Product Change Notice (PCN)

Subject: Addition of production sites for RL78/G11(16pin), G1P, I1D, G1A.

**Difference of specification
(RL78 family HWQFN products)
3mm×3mm 0.5mm pitch 16pin
4mm×4mm 0.5mm pitch 24pin
5mm×5mm 0.5mm pitch 32pin**

MCP-AB-22-0089

Packing specification for Tape & Reel

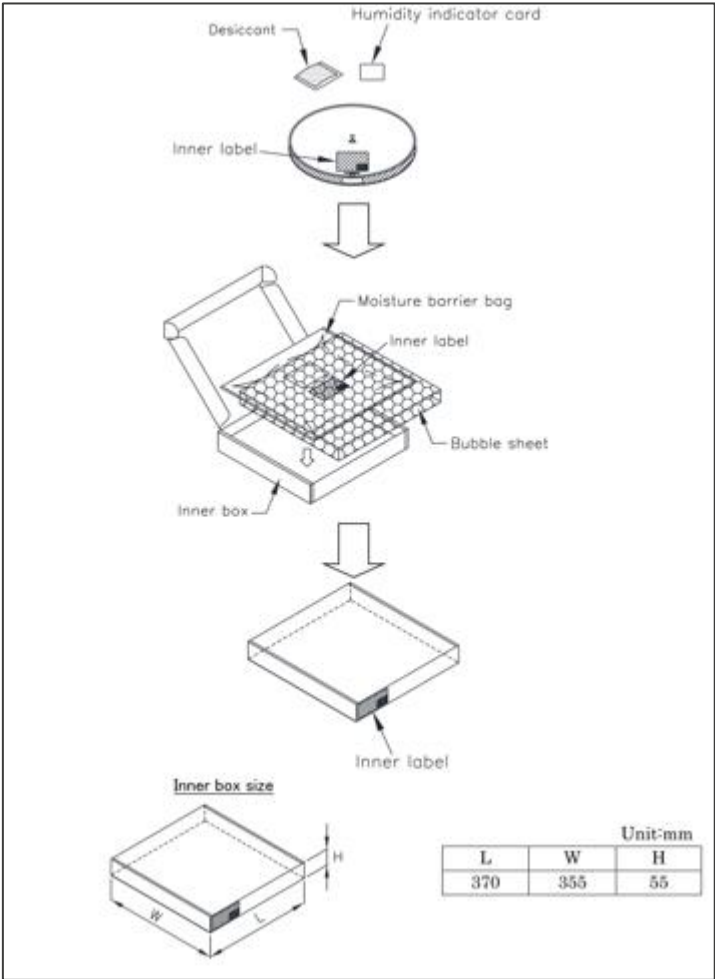
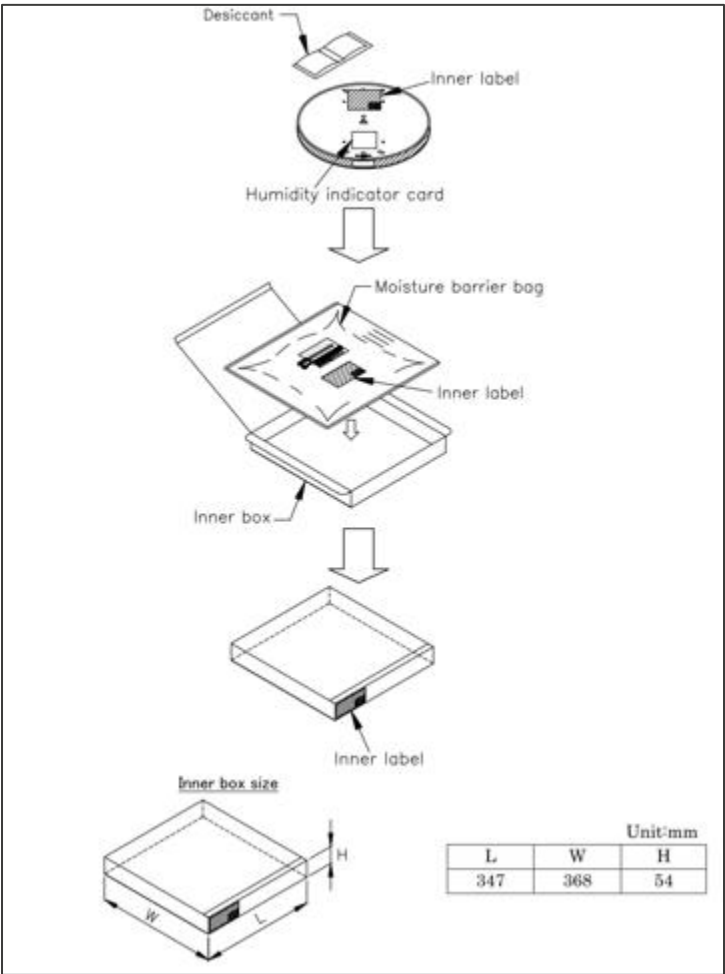
Packing material	Tape & Reel	
	Additional (UTAC)	Existing (KYEC)
Moisture barrier bag *Refer to page 18 for printed characters.	•Size : 406.4mm×457.2mm 	•Size : 415mm×500mm 
Inner box	•Size : 370mm×355mm×55mm 	•Size : 347mm×368mm×54mm 
Desiccant	•Weight : 33g 	•Weight : 25g+25g
